# Access Compliance Report

## Public Rights-of-Way

### (Curb Ramps)

Intersection ID: 13683	Main Street: ELIZABETH_AV	Cross Street: CHARLOTTETOWNE_AV	Location:	N
ADA ID: 875581BF29BA	Ramp Type: Perp	Initial Pass/Fail: Fail	Overall Compliance: No	Severity Score: 8.75
Codes/Mitigation Info/Possible Solution		Field Measurements/Component Compliance

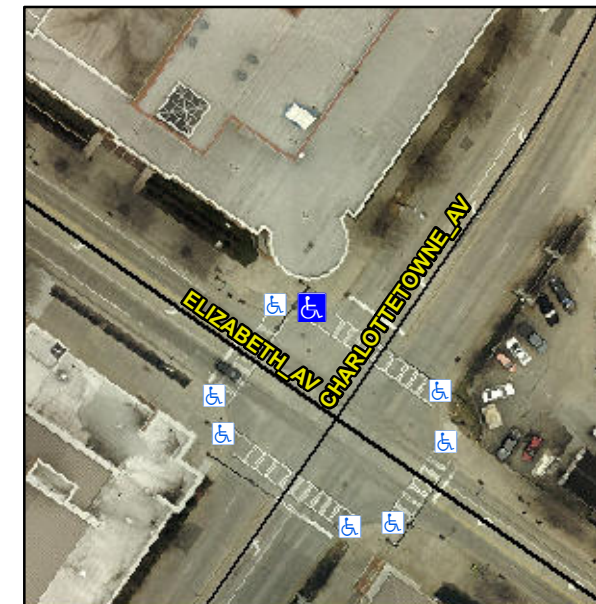
**Remove & Replace Entire Ramp.**

**Not Found, R304.5.1**

Compliance	Description	Data	Compliance	Description	Data
N/A	Ramp Length (in)	85.0	Yes	Ramp Slope (%)	8.0
No	Ramp Width (in)	47.5	Yes	Ramp XSlope (%)	1.6
N/A	Flare Type LT	N/A	N/A	Flare Type RT	N/A
N/A	Flare Slope LT (%)	N/A	N/A	Flare Slope RT (%)	N/A
N/A	Flare Traversable LT?	N/A	N/A	Flare Traversable RT?	N/A
N/A	Landing Length (in)	N/A	N/A	DWS Provided?	N/A
N/A	Landing Width (in)	N/A	N/A	DWS Contrast?	N/A
N/A	Landing Slope (%)	N/A	N/A	DWS Length (in)	N/A
N/A	Landing X Slope (%)	N/A	N/A	DWS Full Width?	N/A
N/A	Landing Curb? (Y/N)	N/A	N/A	DWS Offset (in)	N/A
N/A	Shared Landing?	N/A			
N/A	Gutter Ponding?	N/A	N/A	Gutter Slope (%)	N/A
N/A	Gutter Lip Ht (in)	N/A	N/A	Gutter X Slope (%)	N/A
N/A	Painted X Walk1?	Yes	N/A	Painted X Walk2?	N/A
	X Walk 1 Direction	To SE		X Walk 2 Direction	N/A
N/A	X Walk 1 Width (in)	106.0	N/A	X Walk 2 Width (in)	N/A
	X Walk 1 Slope (%)	3.6		X Walk 2 Slope (%)	N/A
	X Walk 1 X Slope (%)	0.7		X Walk 2 X Slope (%)	N/A
